TABLE OF CONTENTS
FOR
SERVICE BULLETINS

STERILIZER PRODUCTS SERVICE BULLETIN NUMBER: 100

Subject: New Procedure for Adjusting the Pressure / Temperature Potentiometers

STERILIZER PRODUCTS SERVICE BULLETIN NUMBER: S101

Figure 2. Potentiometer Adjustments

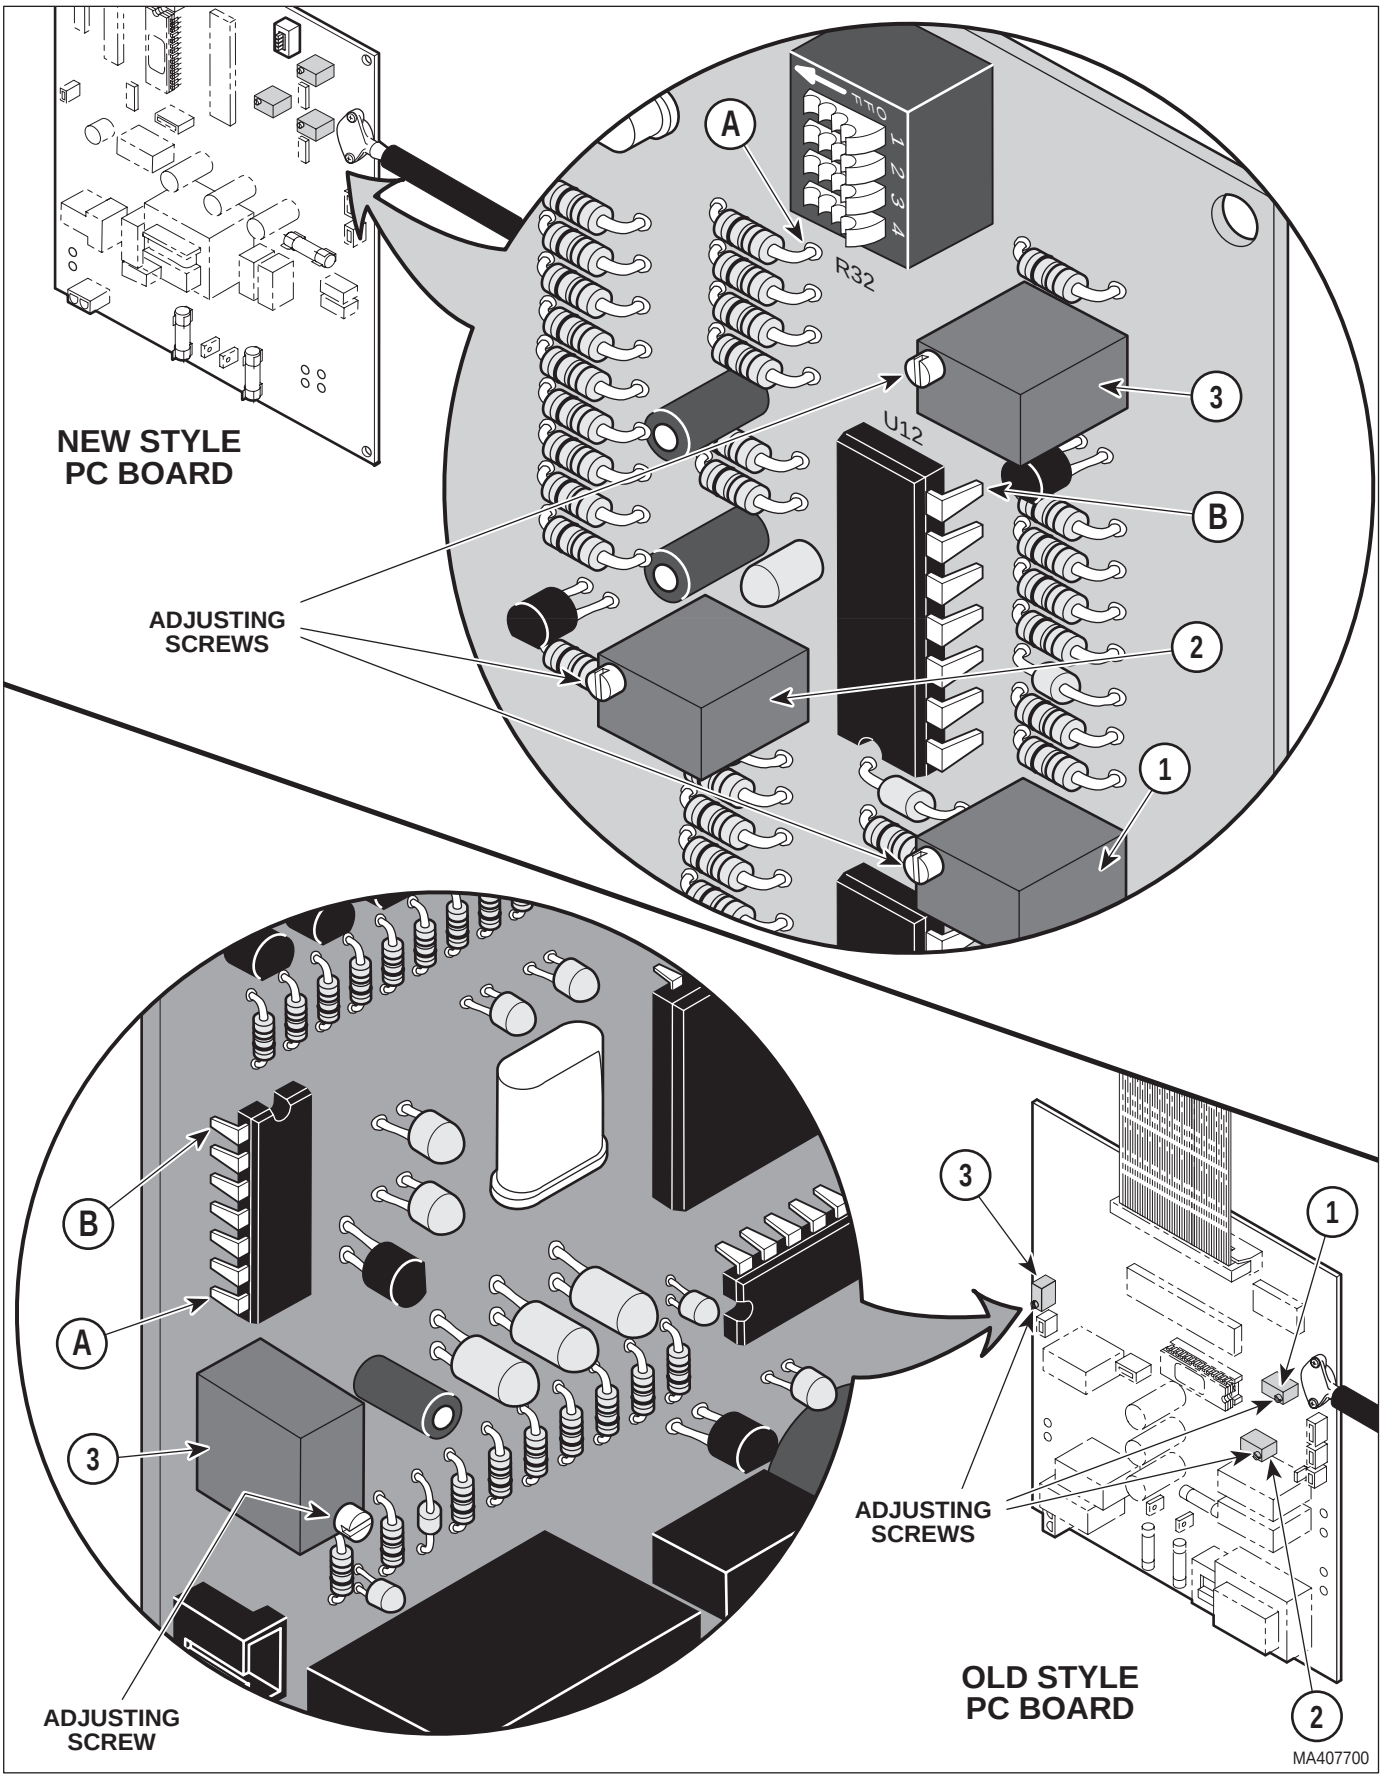
Midmark Engineering has developed a new procedure for adjusting the Pressure / Temperature potentiometers. The new procedure is quicker and more precise than the present procedure is. Perform the new adjustment procedure as follows:

EQUIPMENT ALERT
The pressure zero, pressure range, and temperature potentiometers must not be adjusted separately. If one potentiometer needs to be adjusted, then the entire potentiometer adjustment procedure must be performed, and it must be performed in the proper sequence as follows:

(5) Turn adjusting screw of pressure zero potentiometer (1, Figure 2) in the counter-clockwise direction until the PRESSURE (PSI) display reads 0.0 psi (0.0 kPa).

(6) Turn adjusting screw of pressure zero potentiometer (1) in the clockwise direction until the PRESSURE (PSI) display reads 0.1 psi (1 kPa).

(8) The multimeter should read 2.550 VDC ±0.001 VDC. If multimeter reading is not 2.550 VDC ±0.001 VDC, adjust the adjusting screw of the temperature potentiometer (3) in a clockwise direction to lower the voltage setting or a counter-clockwise direction to raise the voltage setting until the multimeter reading is 2.550 VDC ±0.001 VDC.

(12) Turn the adjusting screw of the pressure range potentiometer (2, Figure 2) in the clockwise or counter-clockwise direction until the reading on the PRESSURE (PSI) display matches the reading of the Pressure Gauge Test Harness within a tolerance of ±0.5 psi (3.5 kPa).
